**CITY OF BALTIMORE
DEPARTMENT OF GENERAL SERVICES
CAPITAL PROJECTS DIVISION**

Addendum No. 2

**For: CONTRACT NO. PRJ000889
HARFORD SENIOR RENOVATIONS & ENVELOPE UPGRADES**

SITE PLAN
SCALE: 1" = 30'

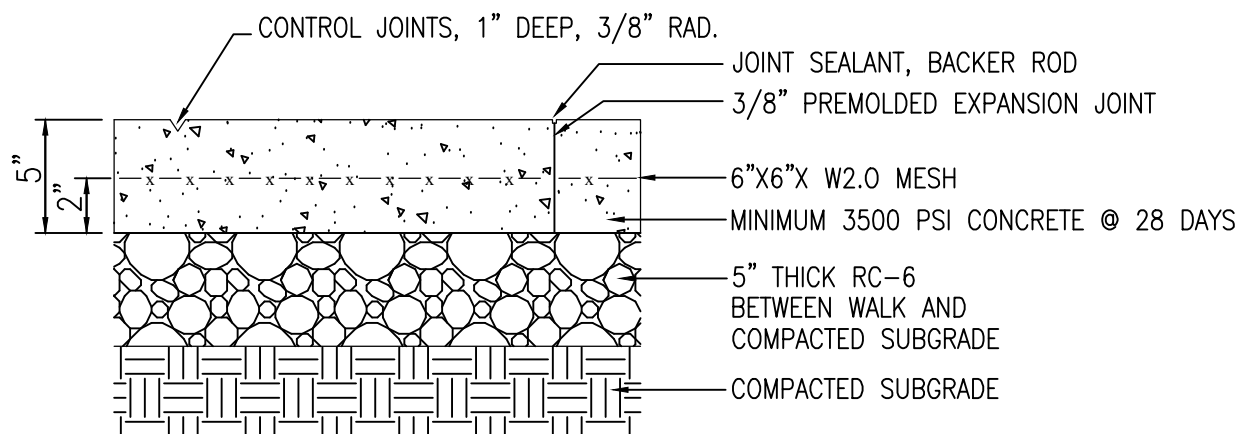
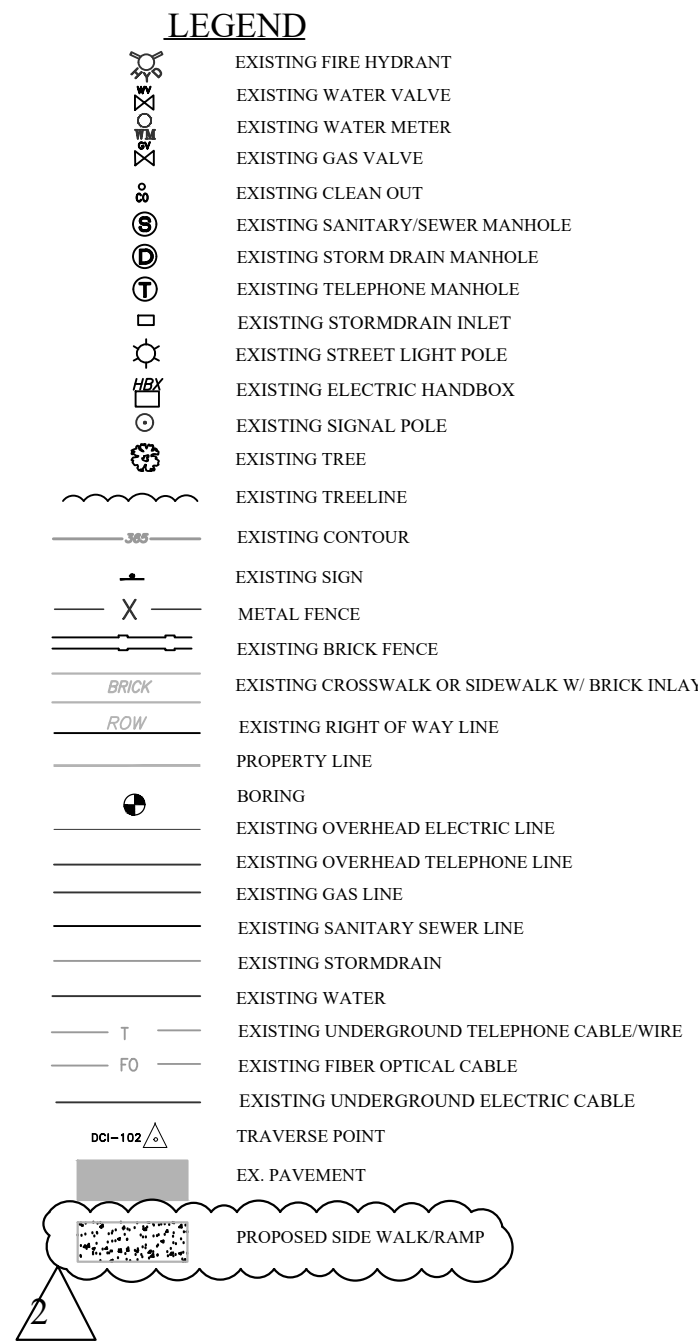
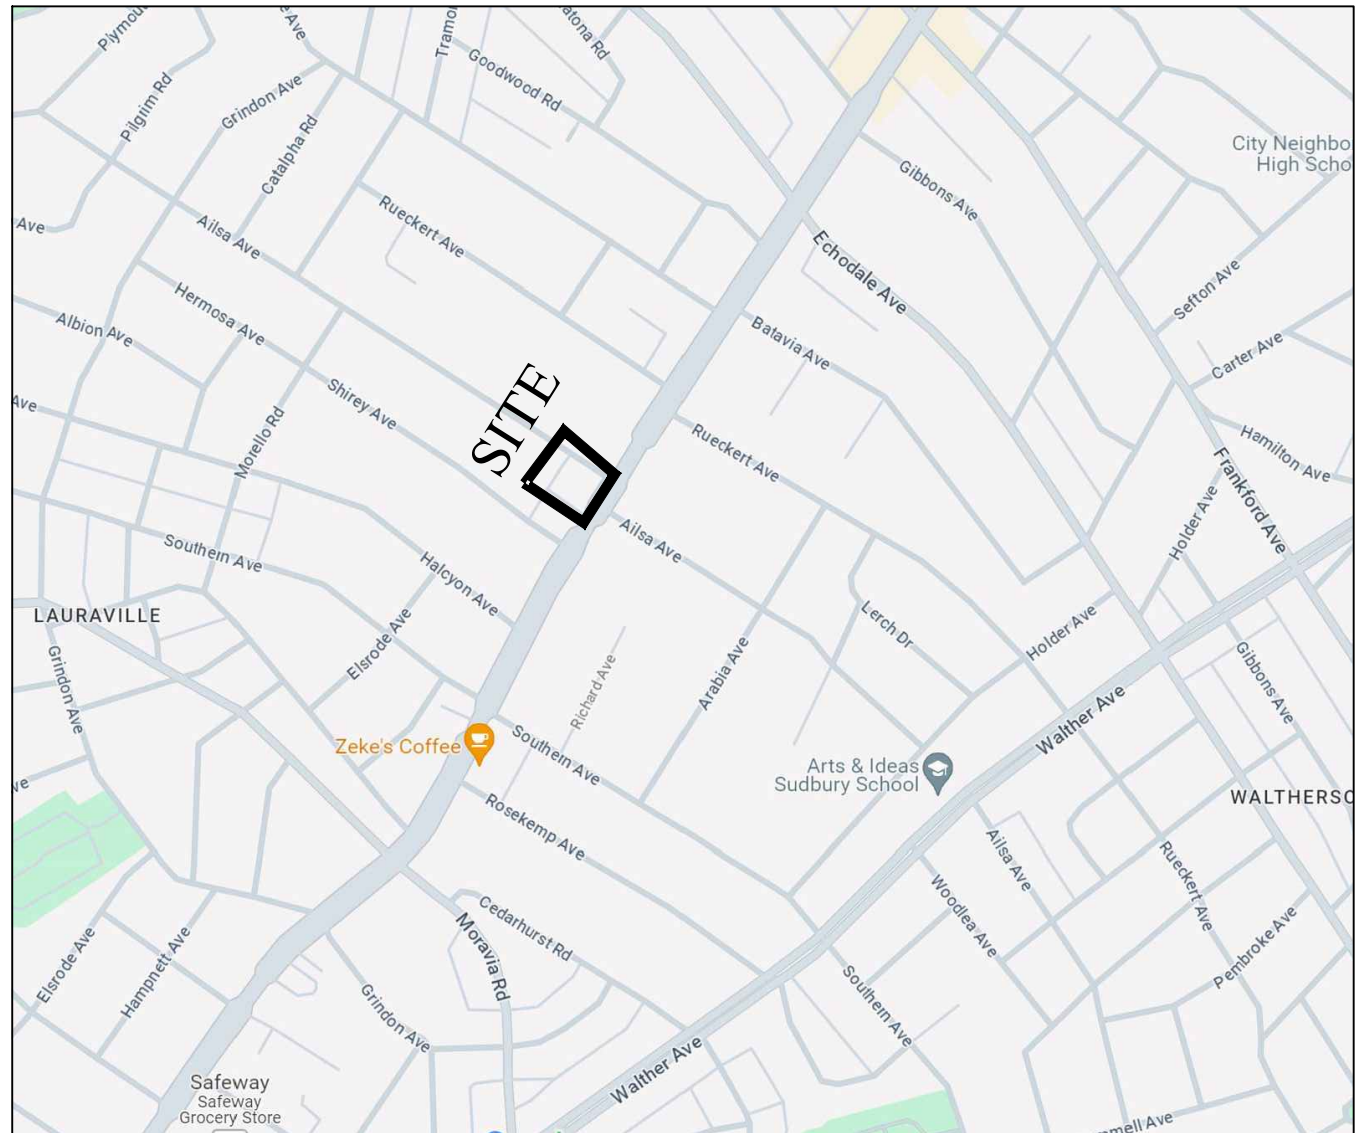
9. (Q): Since the existing front steps and landing are to be replaced, is the existing front sidewalk leading to the front steps to be replaced as well? Not indicated.
(A): **Intent is to replace the sidewalk as indicated on Drawing A402. See revised civil sheet C-01, which includes a new hatch pattern to delineate the extents of new concrete sidewalk, ramp, and stairs.**

10. (Q): Provide an asphalt patch detail where the downspouts are to be connected to existing drains
(A): **Baltimore City's standard flexible pavement detail has been added to Drawing C-01. The cost for patching shall be considered incidental to the related plumbing work as cutting/patching.**

1. Drawing C-01 "Site Plan"
REMOVE: Drawing C-01 in its entirety
INSERT: Revised Drawing C-01 in its entirety
NOTE: Updated hatch to identify extents of new sidewalk, Added asphalt patch detail
2. Drawing A101 "Floor Plan"
REMOVE: Drawing A101 in its entirety
INSERT: Revised Drawing A101 in its entirety
NOTE: Updated reference to masonry infill detail
3. Drawing A201 "Elevations"
REMOVE: Drawing A201 in its entirety
INSERT: Revised Drawing A201 in its entirety
NOTE: Updated Door 117B elevation
4. Drawing M100 "Mechanical New Work Plan"
REMOVE: Drawing M100 in its entirety
INSERT: Revised Drawing M100 in its entirety
NOTE: Supply cfm has been adjusted for RTU-1 and RTU-2 diffusers
5. Drawing P000 "Plumbing General Notes Legend"
REMOVE: Drawing P000 in its entirety
INSERT: Revised Drawing P000 in its entirety
NOTE: Revised general plumbing note #13.

FLOOR PLAN
SCALE: 1/8"=1'-0"

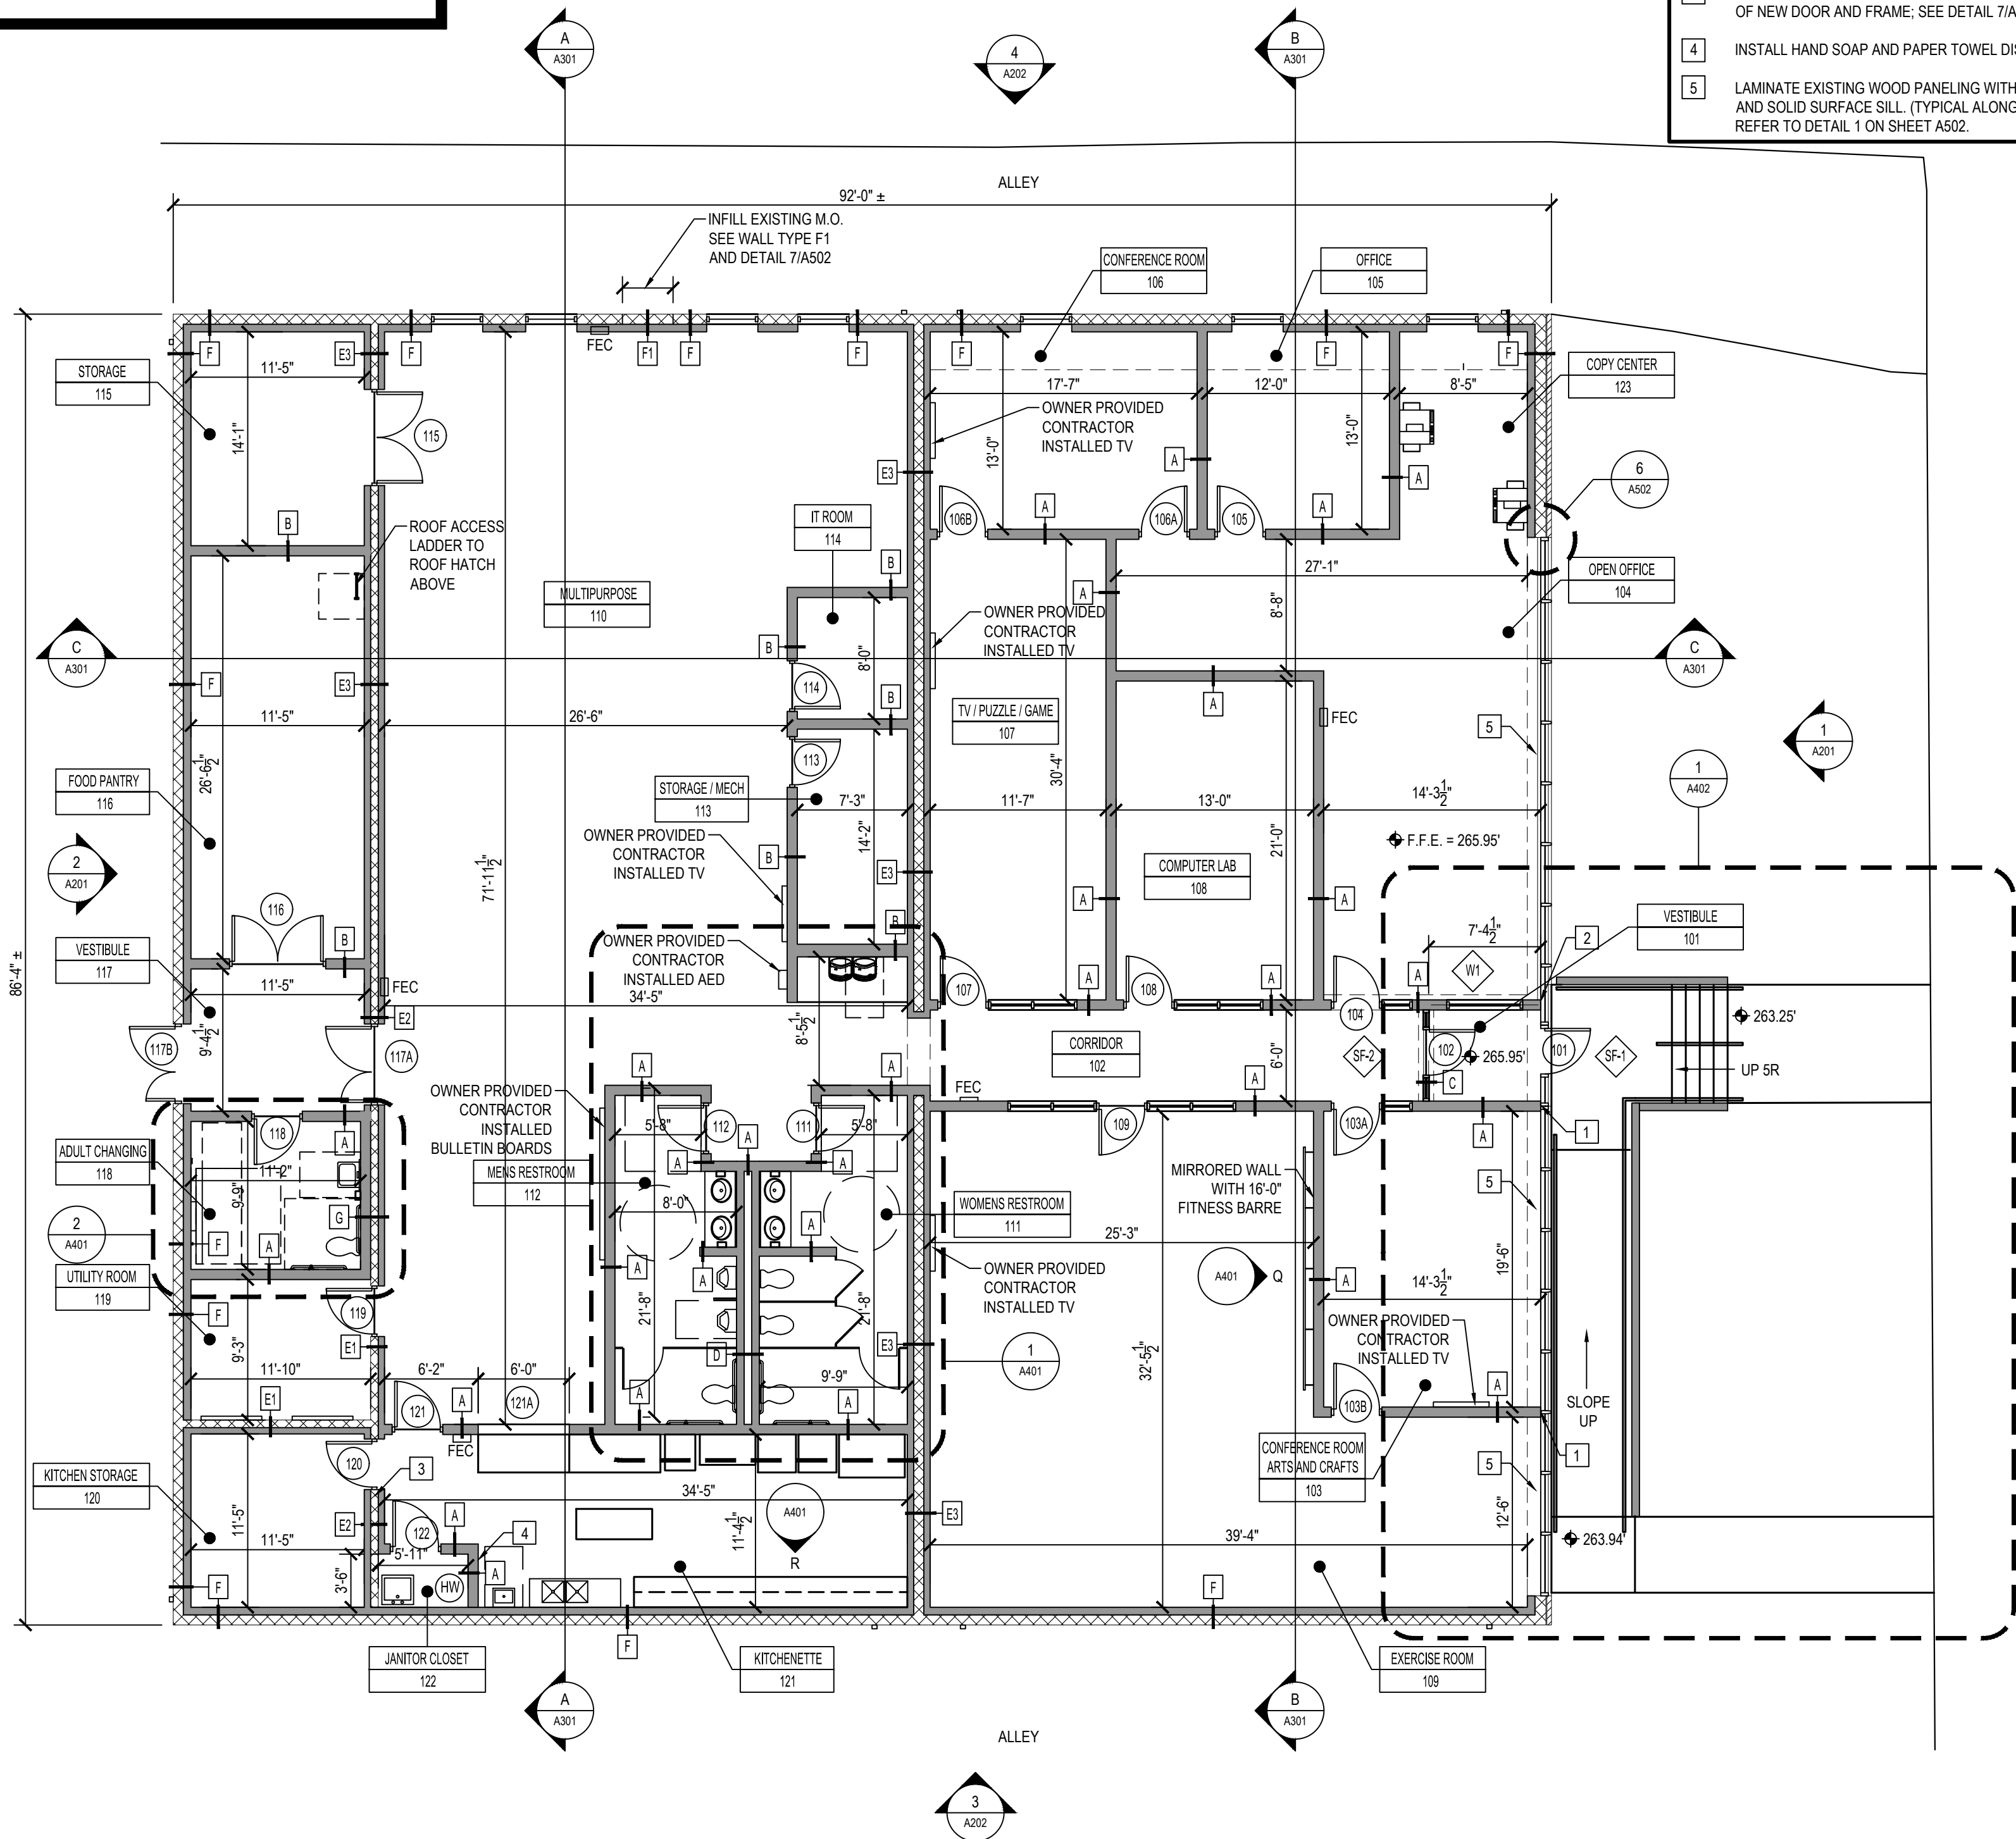
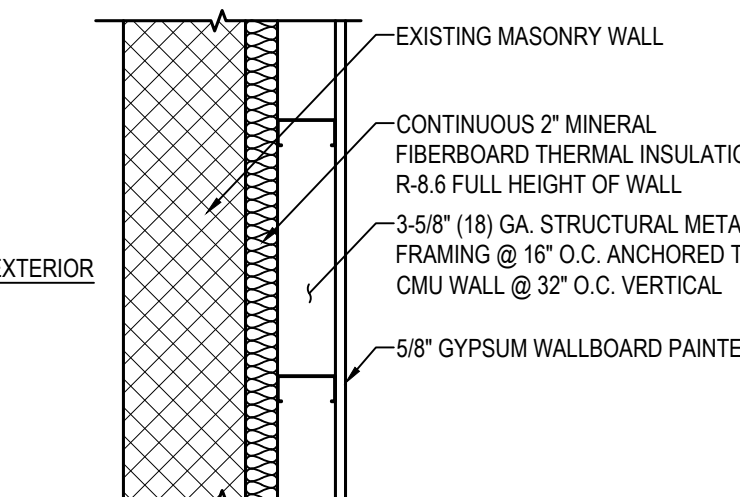
17. (Q): Note that wall type F1 refers to detail 1/A502 which is a storefront section, but detail 7/A502 is probably correct. Confirm.
(A): **Masonry infill at existing walls is to be completed in accordance with detail 7/A502. Please see revised Drawing A101 with updated reference.**

STC 48
F CONSTRUCT WALL FROM FINISH FLOOR TO UNDERSIDE OF ROOF DECK
F1 INFILL EXISTING MASONRY WALL OPENING WITH 8" CMU SEE DETAIL 7 ON SHEET A502
